June 2020 Planning Commission

Engineering Comments Summary

**SPRINGDALE PLANNING COMMISSION
COUNCIL CHAMBERS
201 SPRING
5:00 P.M. JUNE 2, 2020
Tentative Agenda**

To: Planning Commission
From: Staff
Date: June 2, 2020
RE: L20-11 Large Scale Development Williams Tractor

PP #20-03

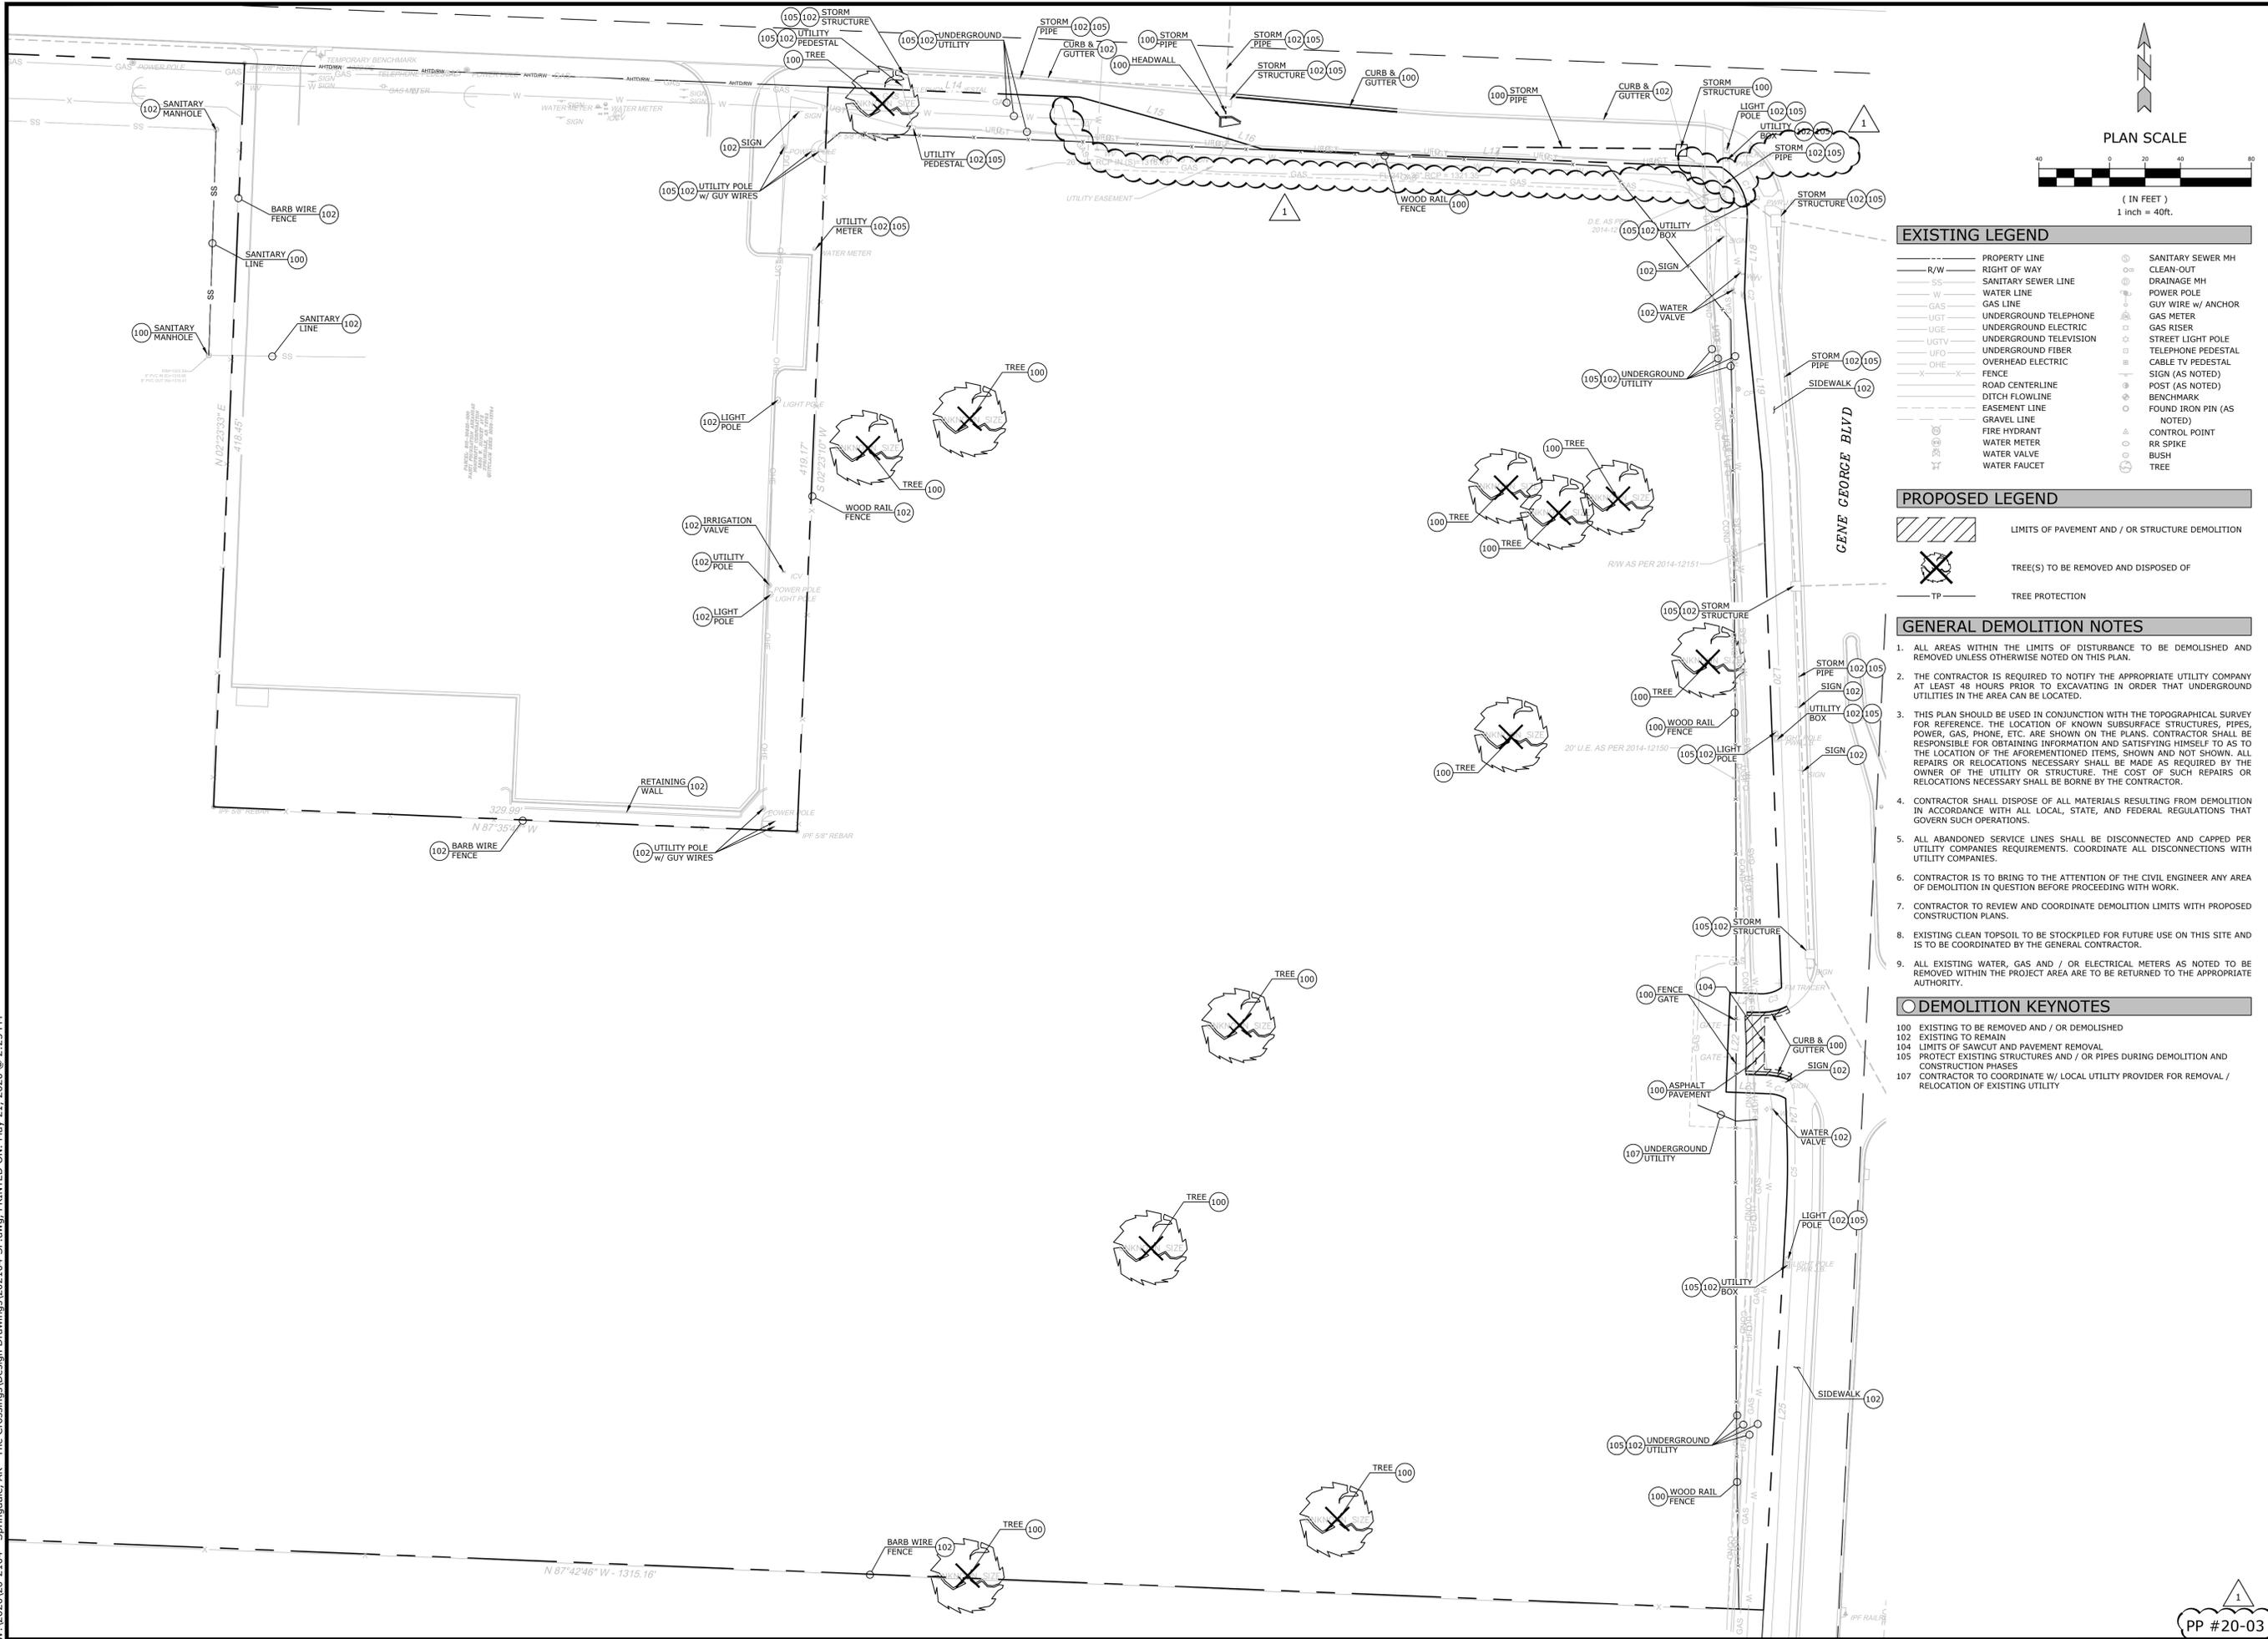
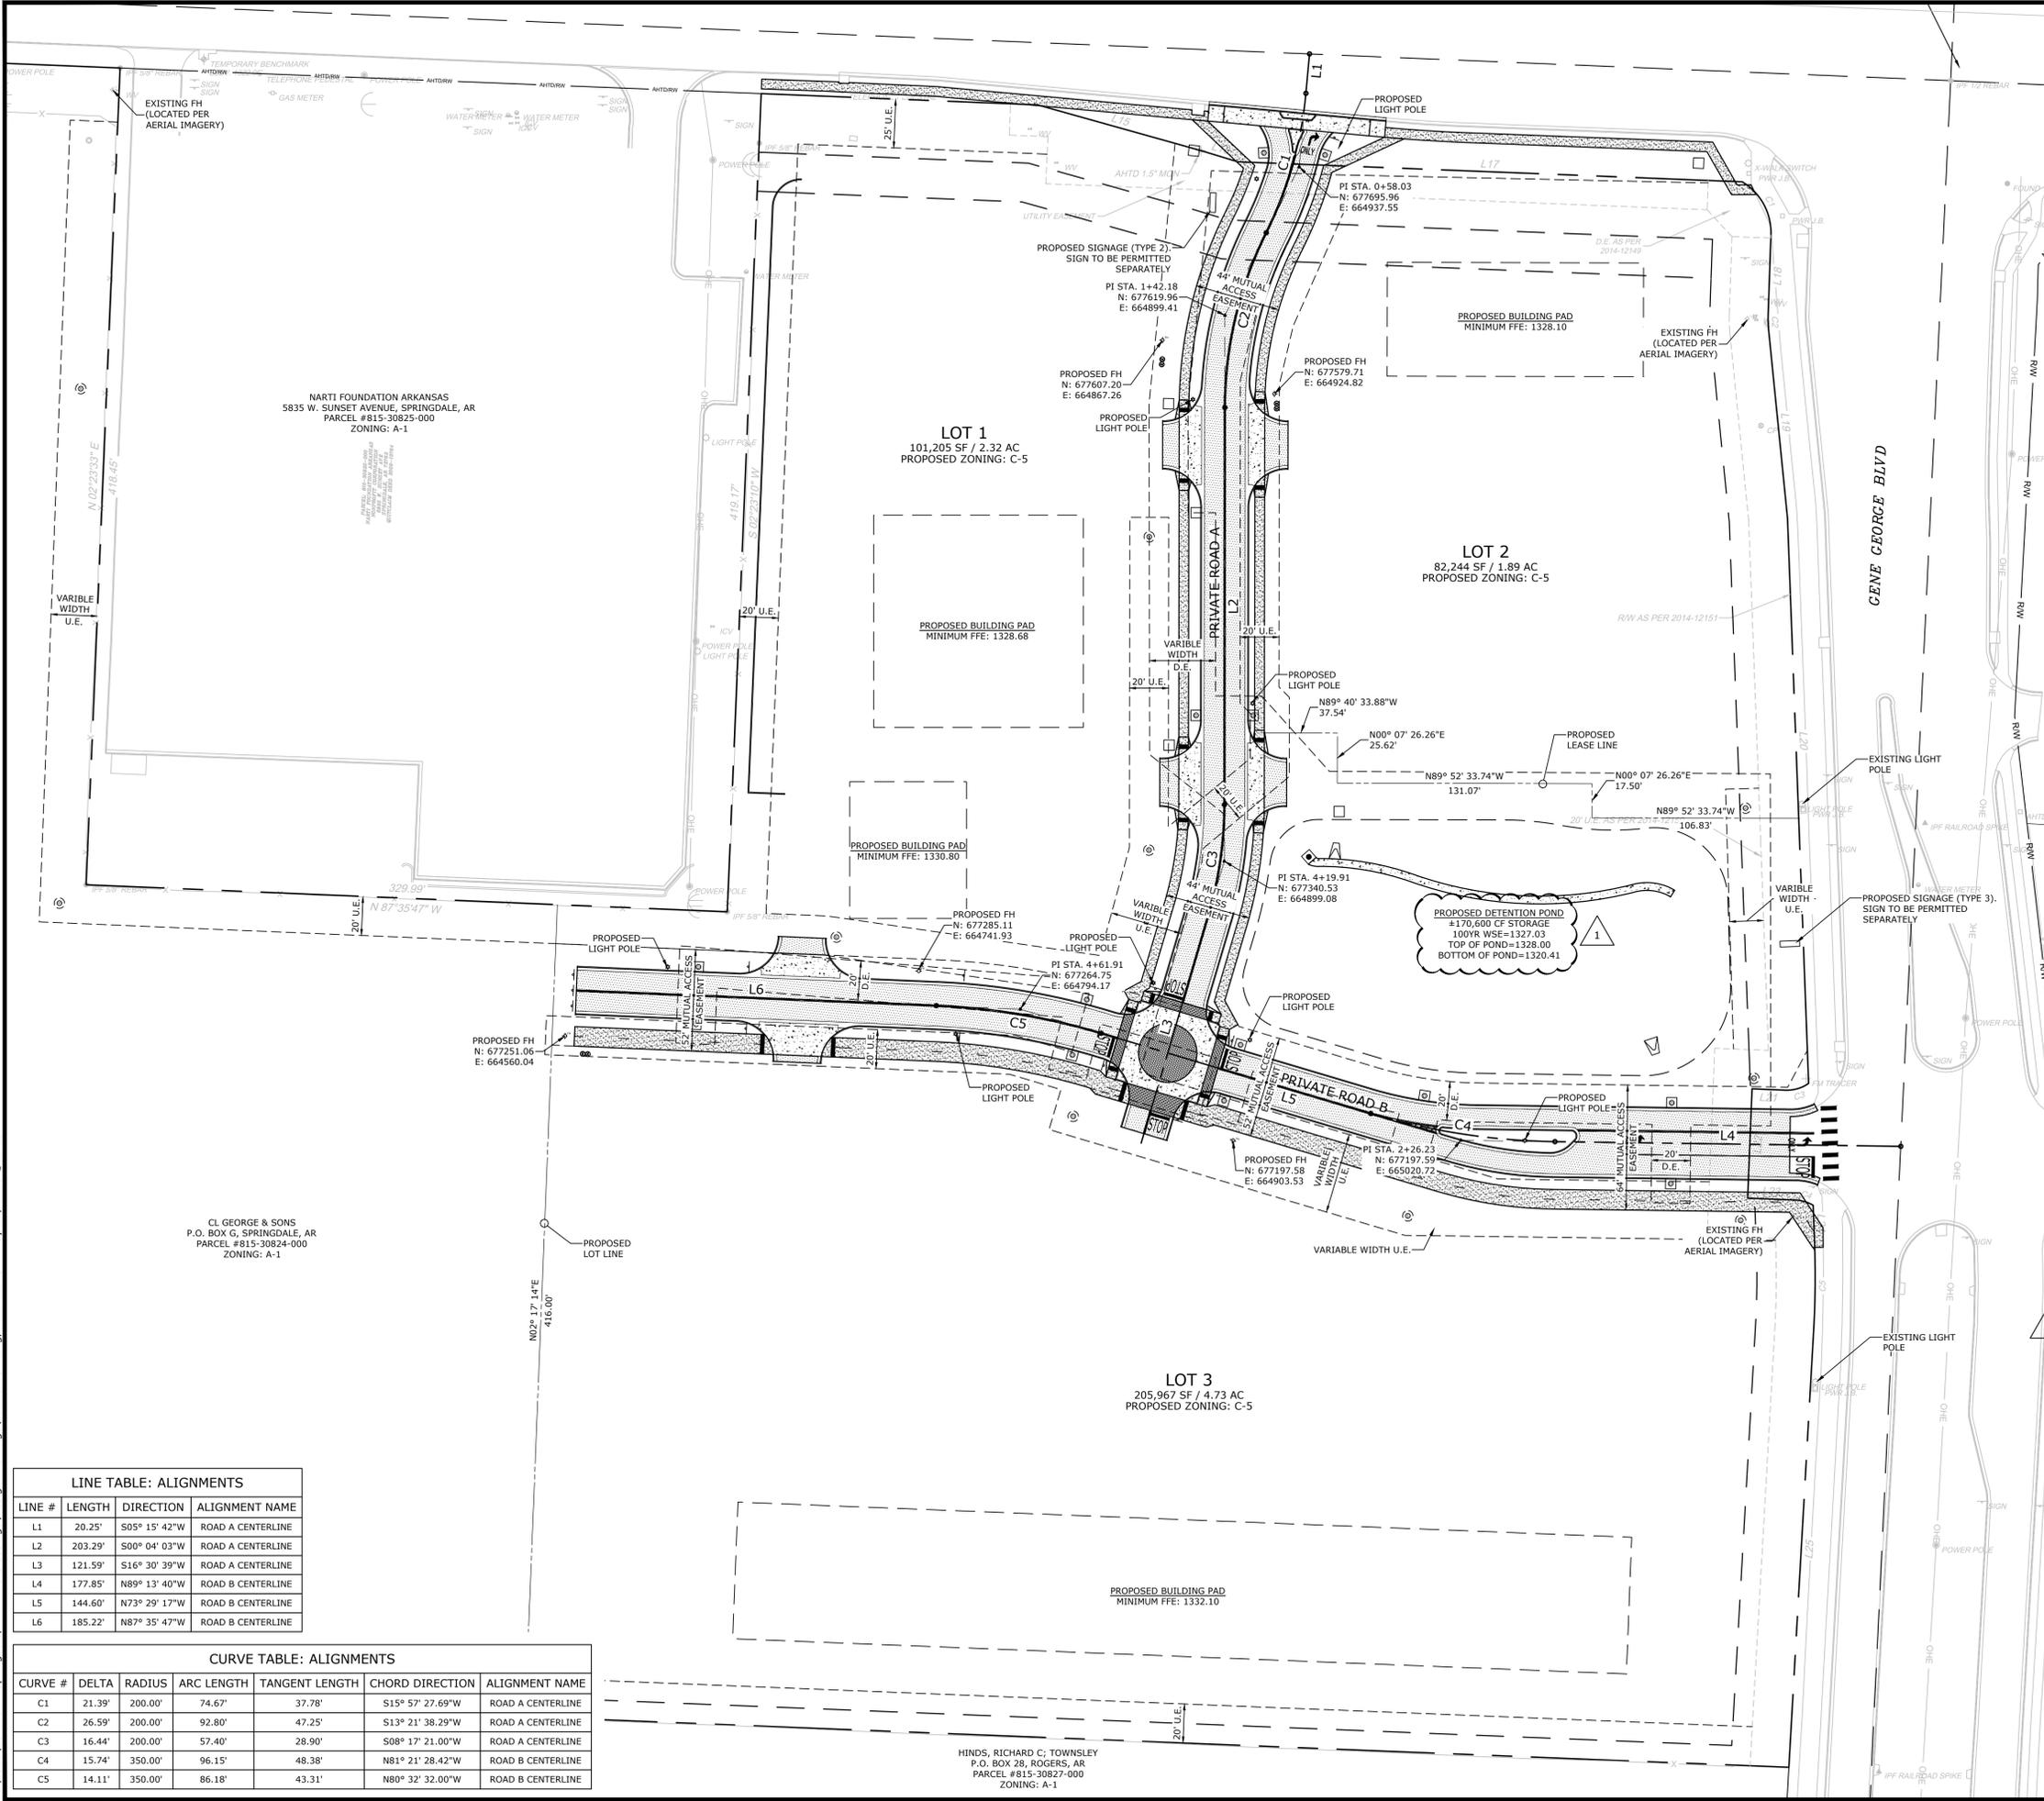
- Need to show proposed/existing streetlights
- Submit Grading Permit application
